STAFF RECOMMENDATION

706 Fatherland Street

August 18, 2021

Application: New Construction – Outbuilding (Detached Accessory Dwelling Unit)
(Revision to a Previously Approved Plan)

COPYRIGHT 2021 b. blanton design
PROJECT: 2029
SCALE: AS NOTED DRAWN BY: BB
SHEET TITLE: EXTERIOR ELEVATIONS

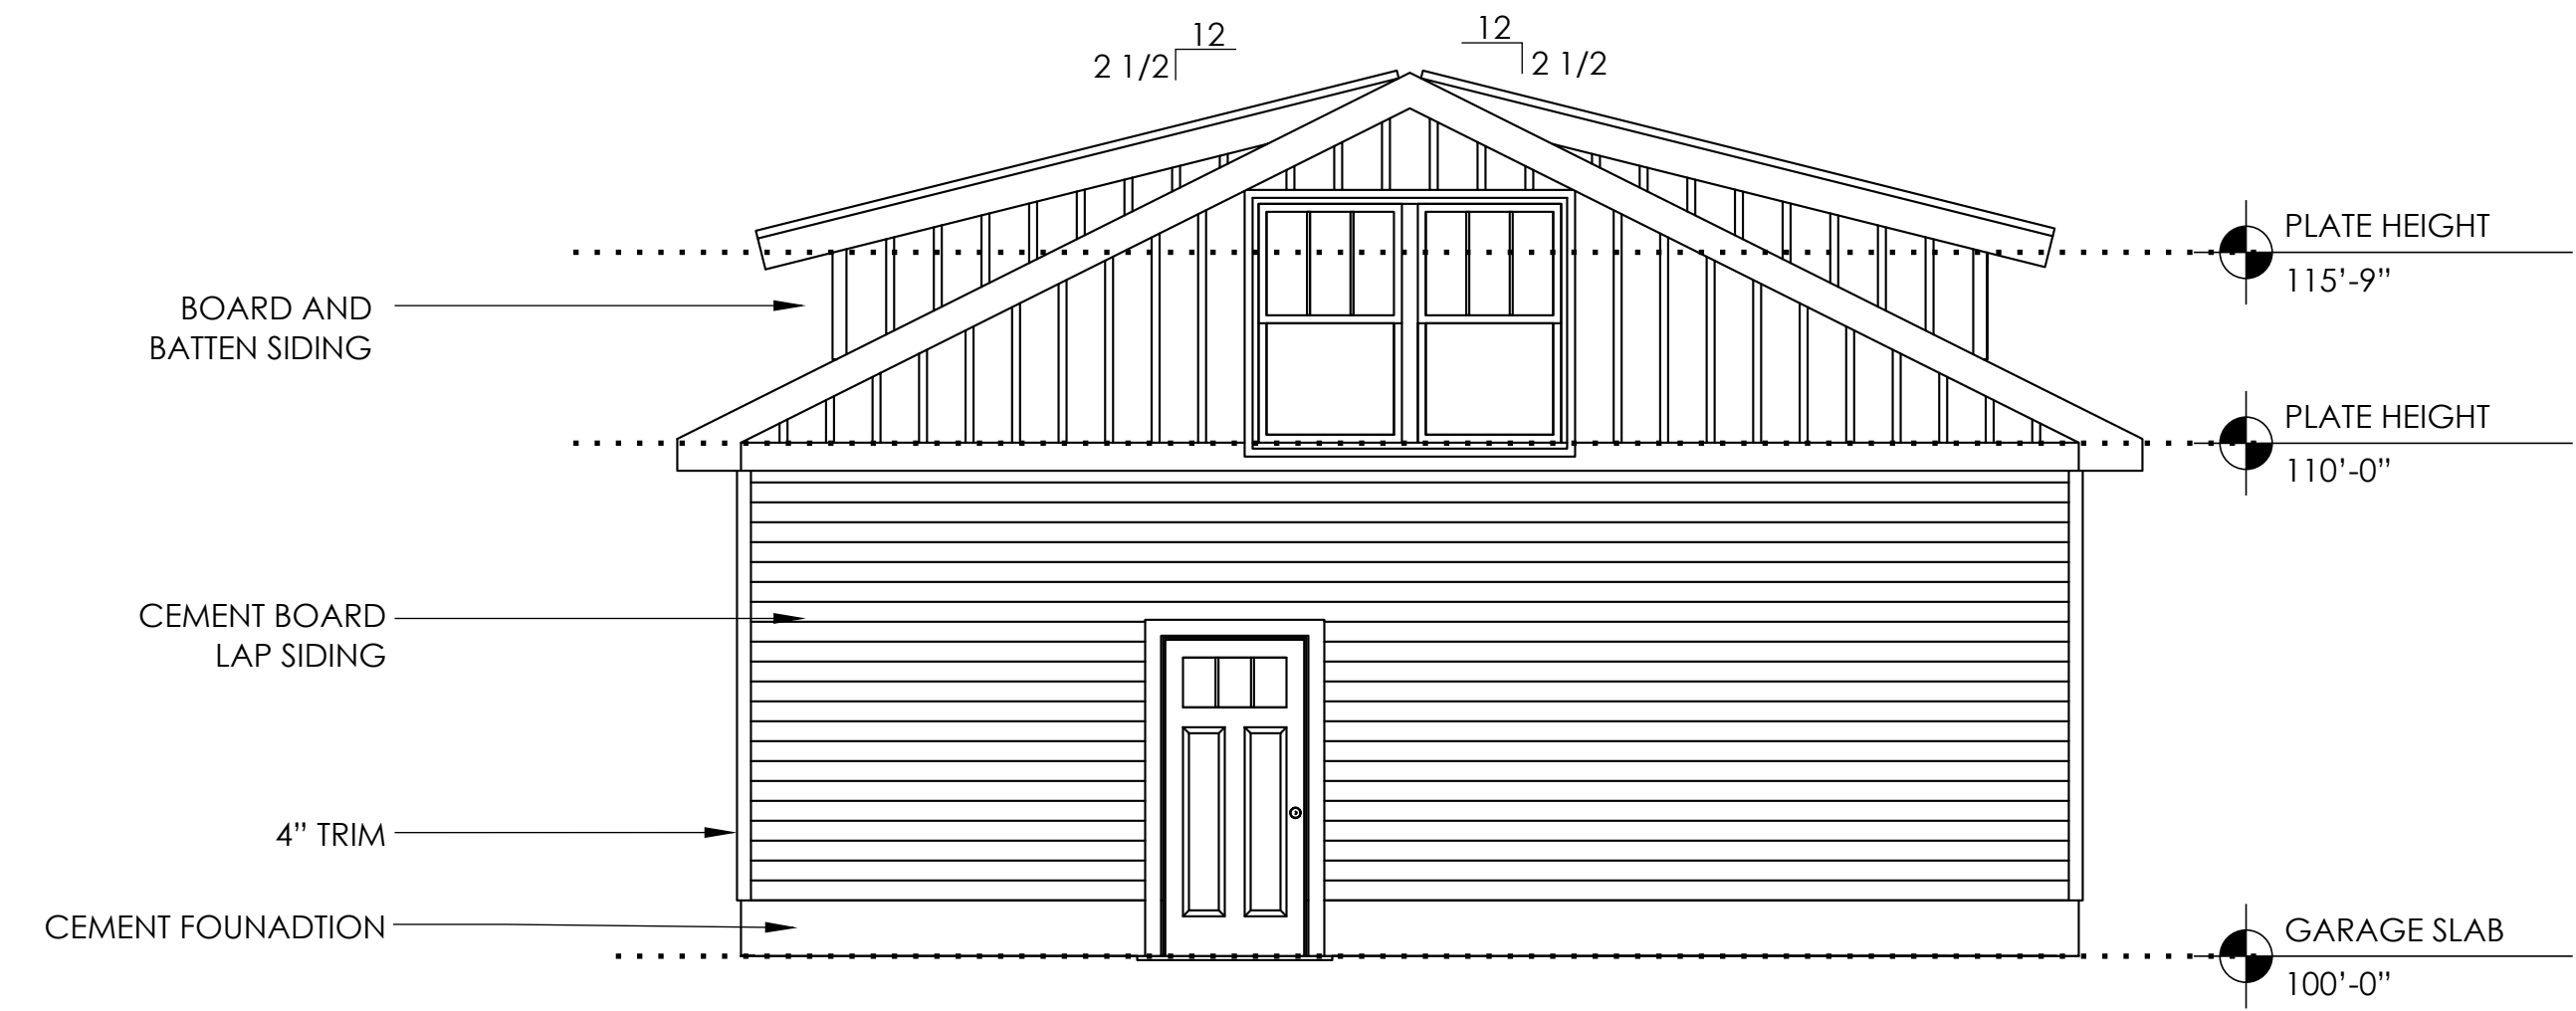
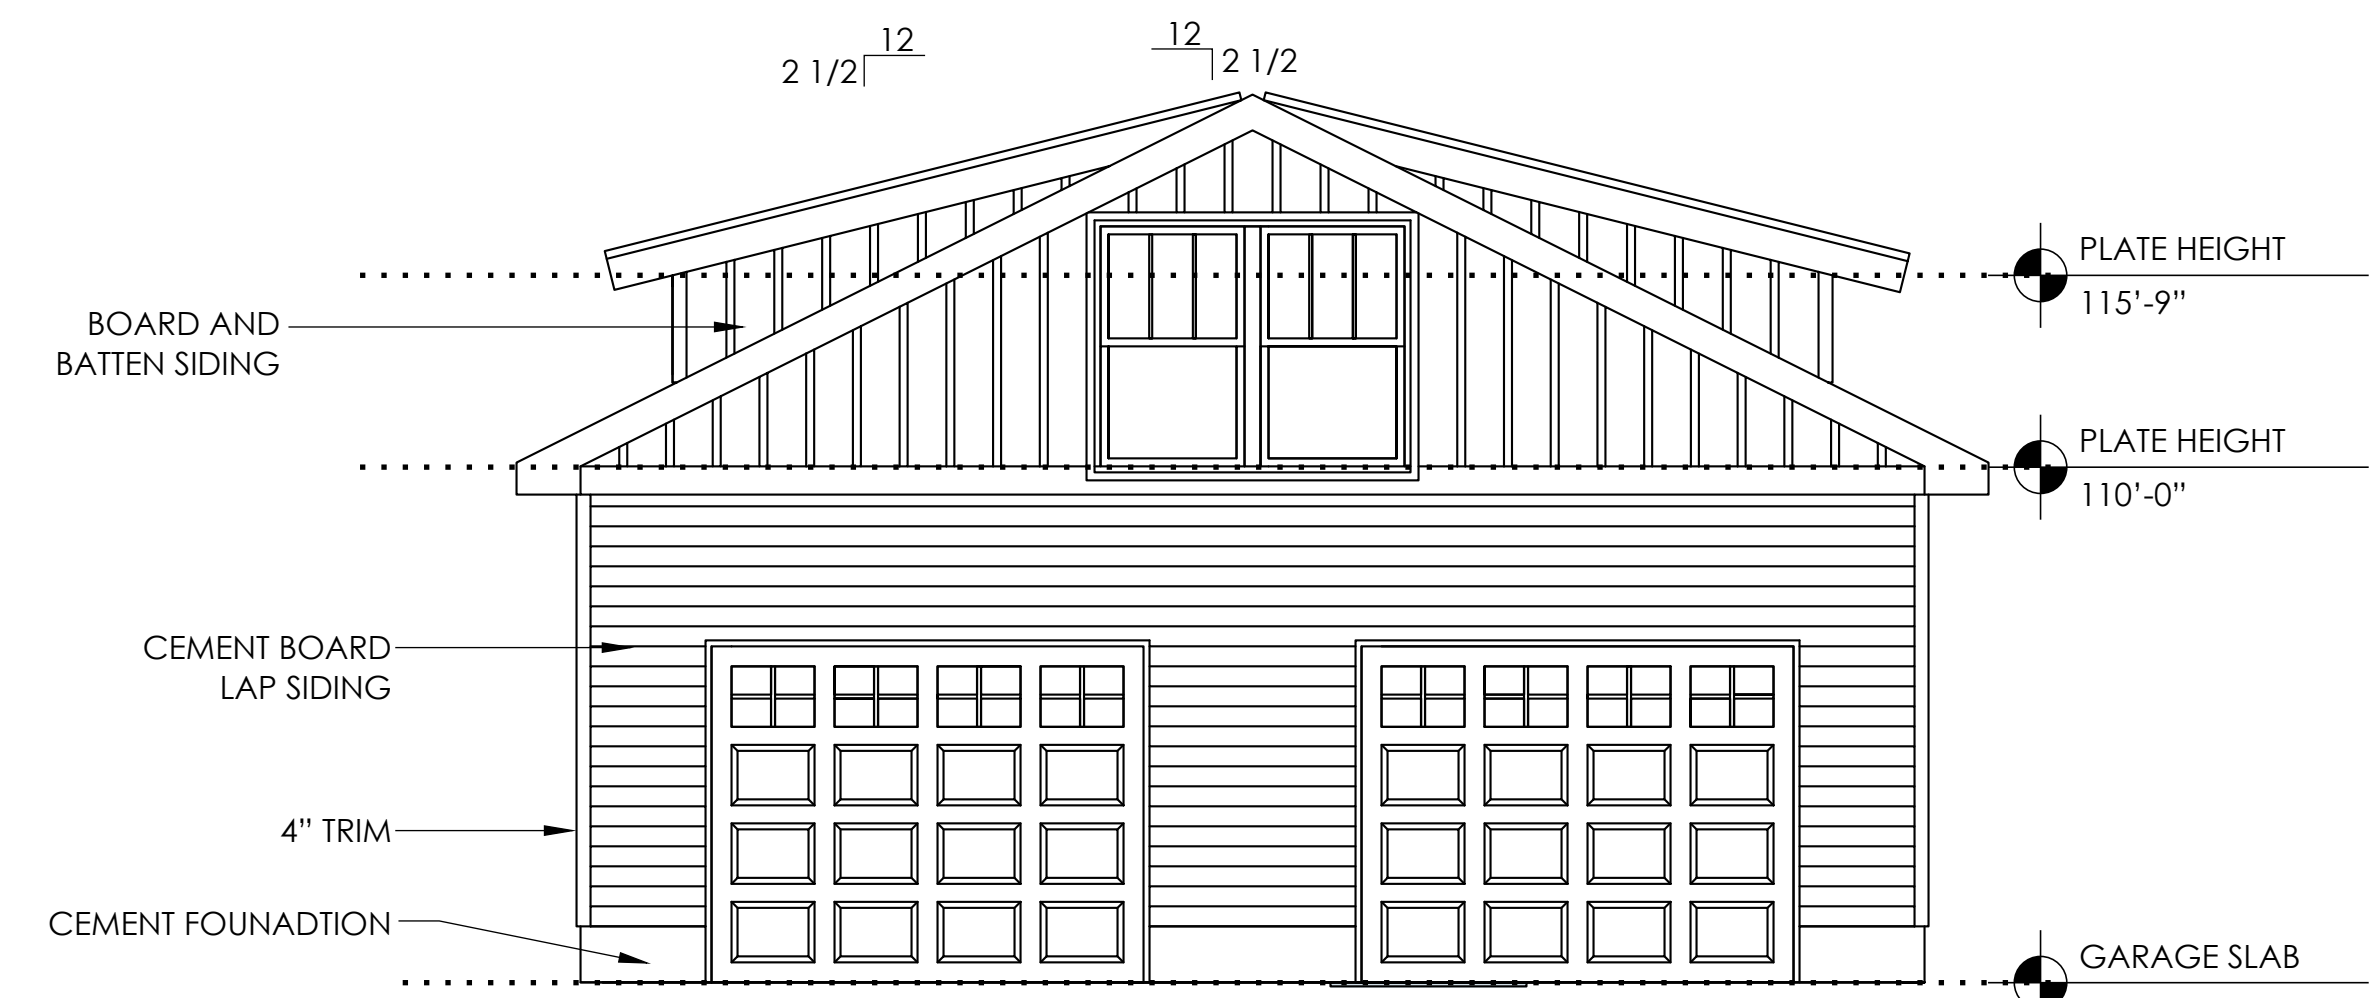
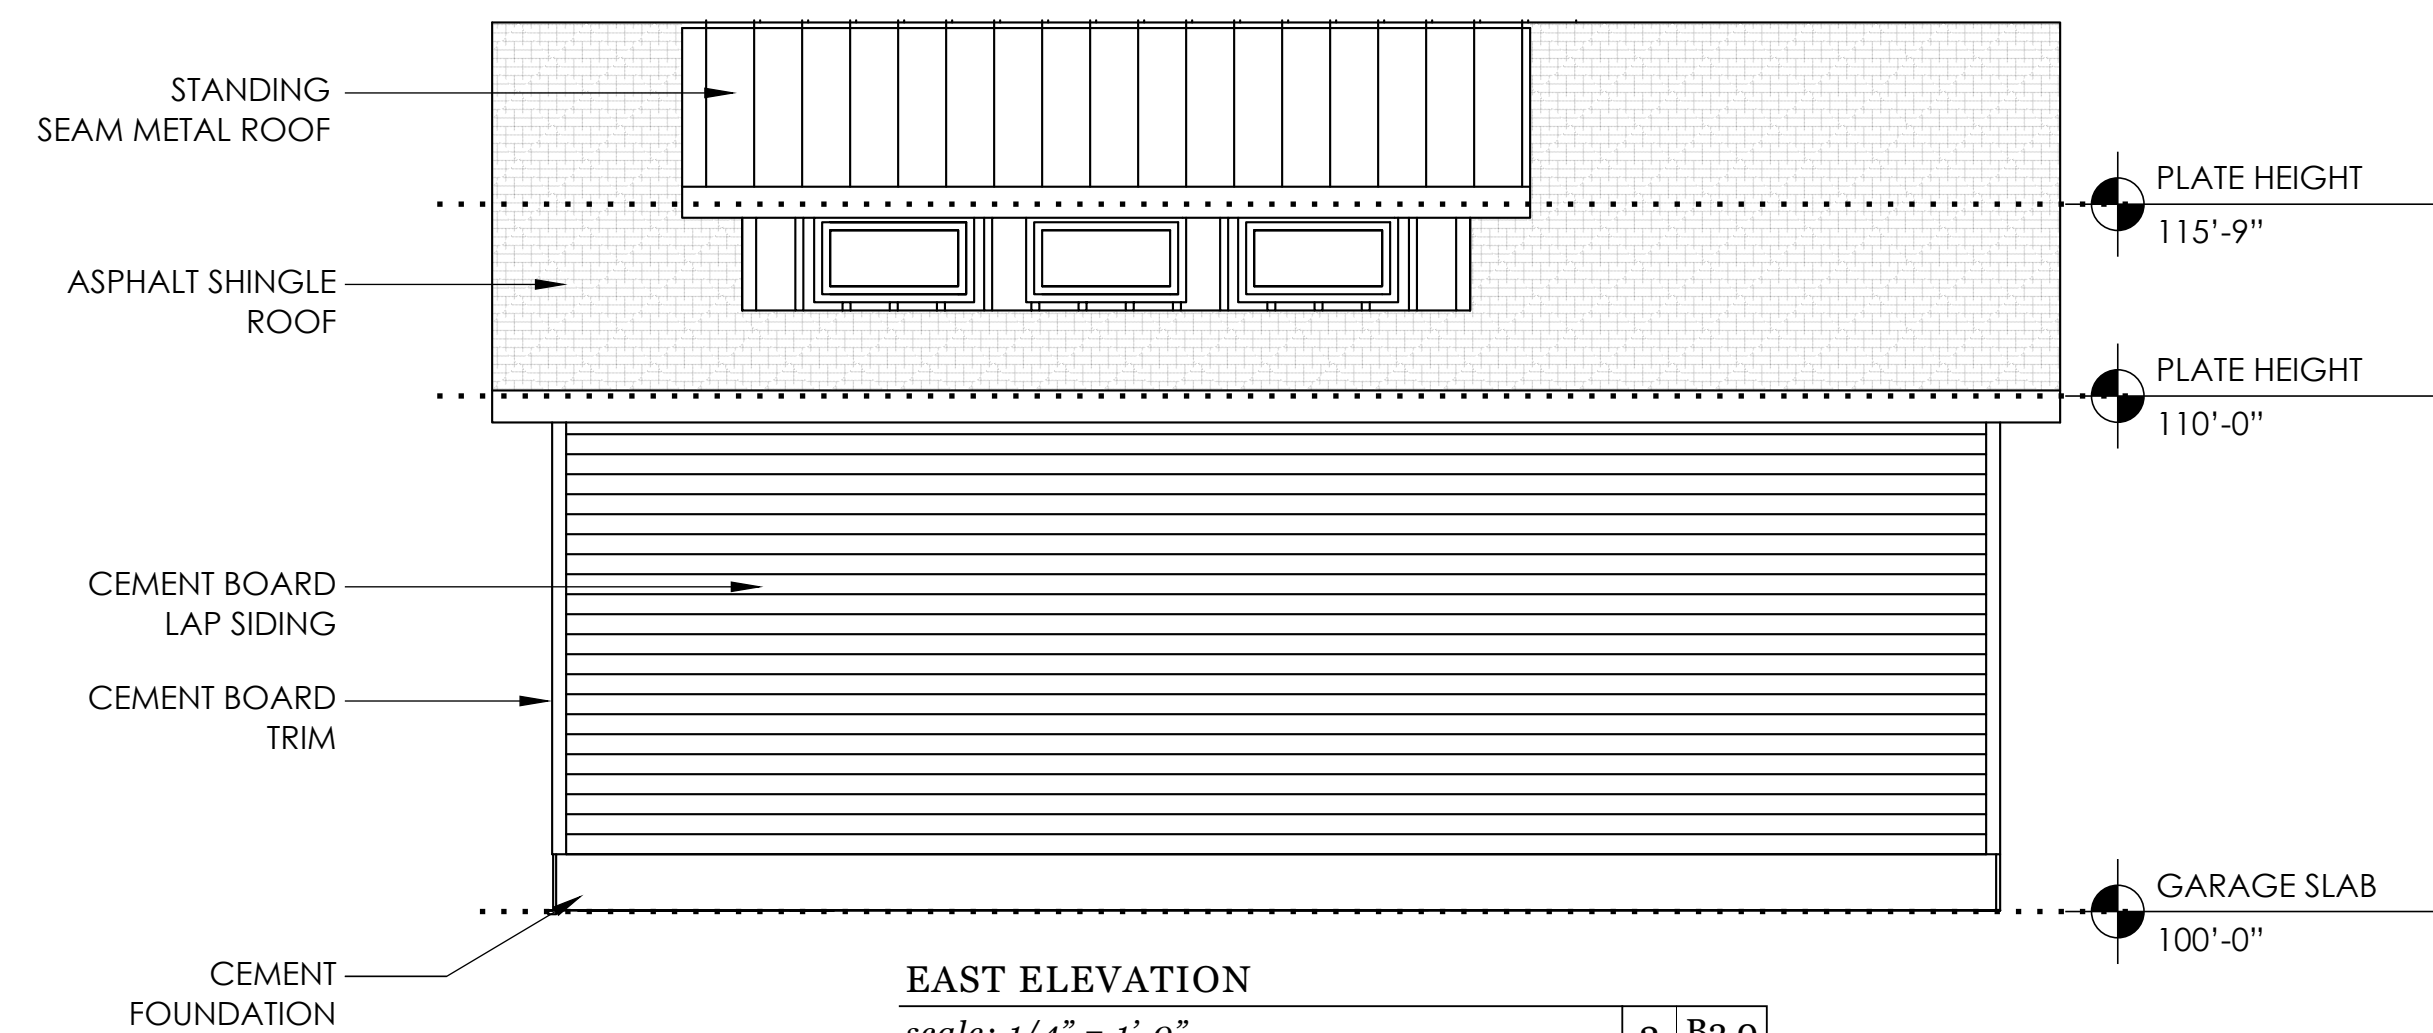
The historic house at 706 Fatherland Street is one-story. The height of the house from finished floor is approximately fifteen feet, six inches (15'-6"), which was field verified by the applicant. The house includes a sixteen-inch (16") foundation, which brings the overall height from grade to sixteen feet, ten inches (16'-10"). The proposed DADU is a one and one-half story structure that is slab on grade with a ridge height of eighteen feet, six inches (18'-6") as measured from grade. While it is often possible to have a one and one-half story outbuilding behind a one-story home, the modest scale of the historic home at 706 Fatherland Street may not make that feasible in this case. Since the lot is larger, it would be possible to increase the footprint to up to one thousand square feet (1000 sq. ft.).

The proposal does not meet Section III.B.2.h.1 of the design guidelines. Since it is not possible to reduce the overall height of the DADU so that it is not taller than the historic house, staff recommends disapproval of the application.

The primary roof form is gabled, which is appropriate. The primary pitch is approximately 5/12 and the dormers have a pitch of 2.5/12, which could be appropriate for dormers if the outbuilding did not exceed the height of the house. Staff finds that the proposal meets Section III.B.2.h.1 of the design guidelines for roof shape.

Recommendation: Staff recommends disapproval of the project, finding that the DADU does not meet Section III.B.2.h.1 of the *Edgefield Historic Zoning District: Handbook and Design Guidelines*.
